# Access Compliance Report

## Public Rights-of-Way

Intersection ID: 30311	Main Street: EUROSTAR_DR	Cross Street: ROCKET_LN	Location:	E
ADA ID: DC3077FD7A71	Ramp Type: PerpDiag	Initial Pass/Fail: Fail	Overall Compliance: No	Severity Score: 10

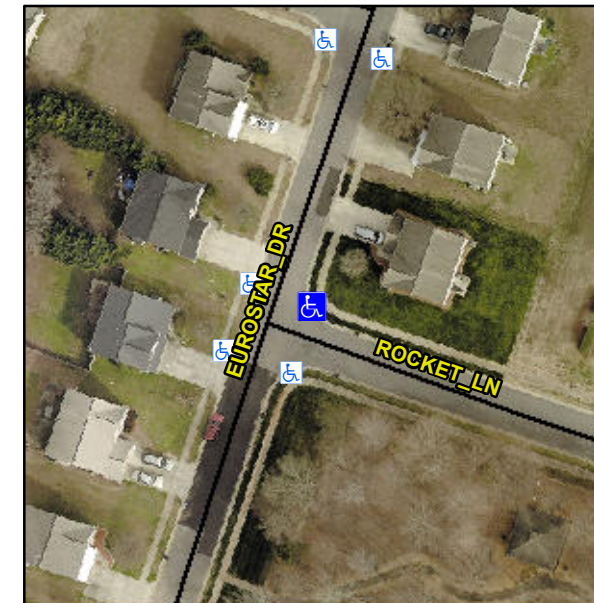
**Not Found, R304.5.1, R304.5.3**

Compliance	Description	Data	Compliance	Description	Data
N/A	Ramp Length (in)	47.0	Yes	Ramp Slope (%)	6.1
No	Ramp Width (in)	43.5	No	Ramp XSlope (%)	4.8
N/A	Flare Type LT	N/A	N/A	Flare Type RT	N/A
N/A	Flare Slope LT (%)	N/A	N/A	Flare Slope RT (%)	N/A
N/A	Flare Traversable LT?	N/A	N/A	Flare Traversable RT?	N/A
N/A	Landing Length (in)	N/A	N/A	DWS Provided?	N/A
N/A	Landing Width (in)	N/A	N/A	DWS Contrast?	N/A
N/A	Landing Slope (%)	N/A	N/A	DWS Length (in)	N/A
N/A	Landing X Slope (%)	N/A	N/A	DWS Full Width?	N/A
N/A	Landing Curb? (Y/N)	N/A	N/A	DWS Offset (in)	N/A
N/A	Shared Landing?	N/A			
N/A	Gutter Ponding?	N/A	N/A	Gutter Slope (%)	N/A
N/A	Gutter Lip Ht (in)	N/A	N/A	Gutter X Slope (%)	N/A
N/A	Painted X Walk1?	No	N/A	Painted X Walk2?	No
	X Walk 1 Direction	To NW		X Walk 2 Direction	To SW
N/A	X Walk 1 Width (in)	N/A	N/A	X Walk 2 Width (in)	N/A
	X Walk 1 Slope (%)	2.0		X Walk 2 Slope (%)	1.4
	X Walk 1 X Slope (%)	0.5		X Walk 2 X Slope (%)	4.0

**Remove & Replace Curb Ramp With Two New Directional Ramps or Equivalent.**
